#### **Attachment 4 25-Foot Radius of Influence for Line Drives**

Attachment 4 Figure 4-1 NRC Modeled Potentiometric Drawdown for Line Drive in Zone 1

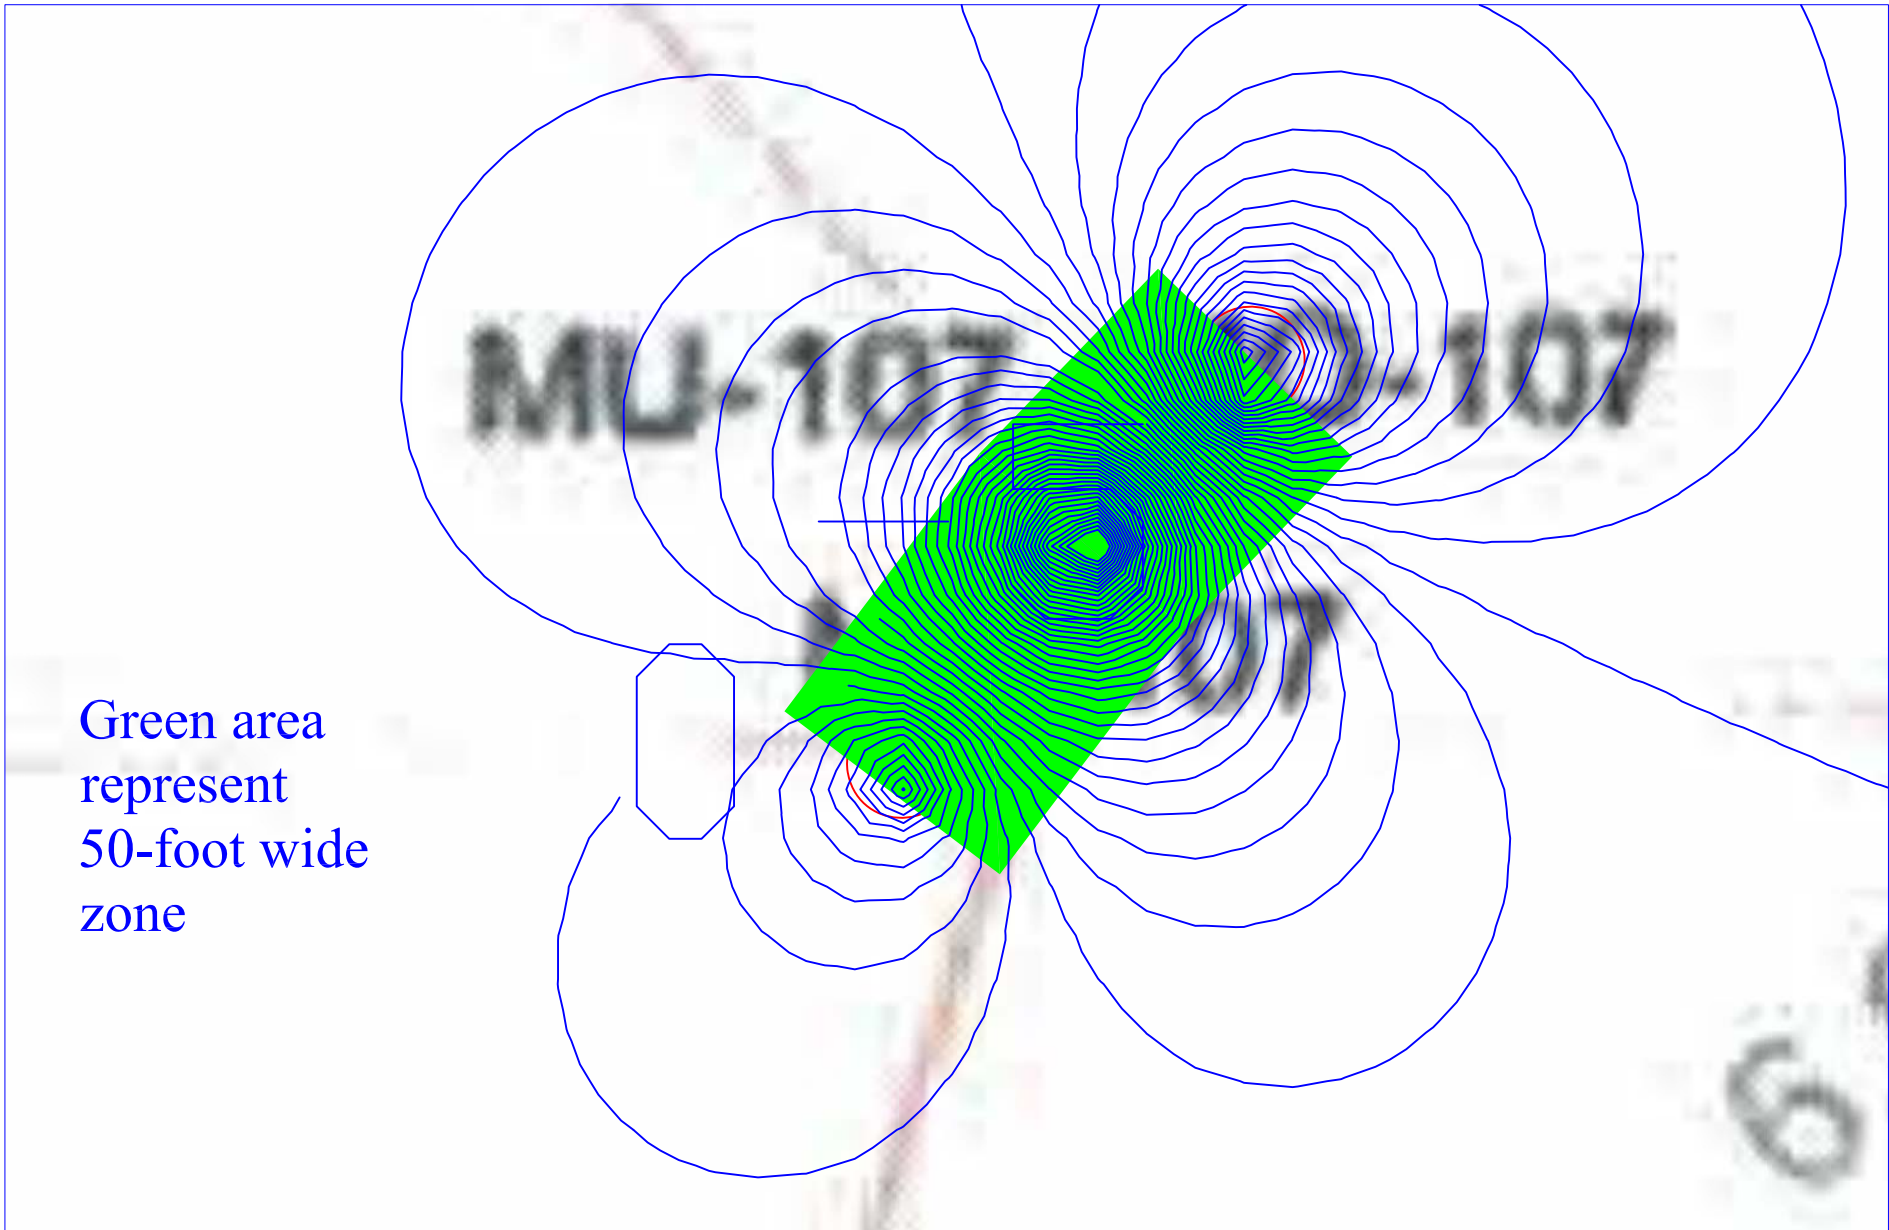
Lost Creek has proposed isolated line drives and suggest that the area of influence for financial surety is a 25-foot radius around each well and each well separated by 50 feet. Lost Creek has not provided justification for the 25-foot radius of influence or any other operational constraints on line drives.

Staff constructed a simple AEM model to verify the area of influence of a line drive (for the model input, see Appendix 4-1). Unfortunately, because of the lack of data to constrain the operations, staff cannot fully evaluate the line drives. However, a contour map of model-predicted surface in Zone 1 is shown on Attachment \$ Figure 4-1 for a line drive which consists of two injection wells and a single extraction well operating at flows one-half those proposed by Lost Creek for a 5-spot pattern. The contours at these low flow rates suggest that the area of influence would exceed 25 feet.

Consequently, Staff cannot verify the 25-foot radius of influence for line drives.
